# **Memorandum**Department of Planning & Development Services

RE: POWER OF REVIEW Monarch Center, Partial Amended Sign Package:

#### **Planning Commission Staff Report**

**Description:** Monarch Center, Partial Amended Sign Package: A request for a Partial Amended

WEST ELEVATION

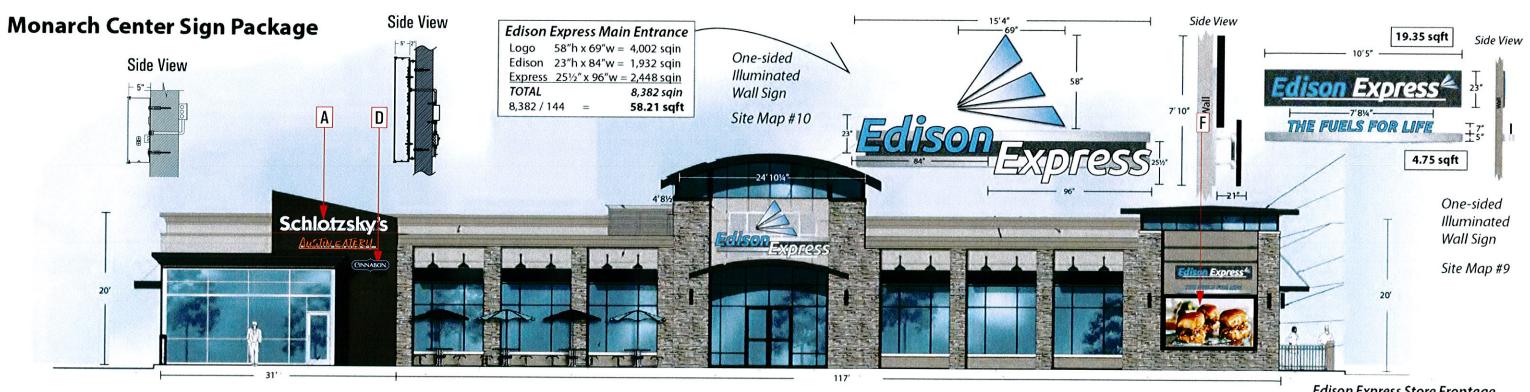
This partial amended Sign Package request for the Edison Express development substantially increases the amount of signage on each of the three impacted elevations. The request does not propose eliminating any signage elsewhere within the development to compensate for or mitigate the requested increase. While there are multiple uses within this building, the proposed signage for the restaurant tenant is spread across three elevations rather than being contained to the exterior walls of the particular tenant space.
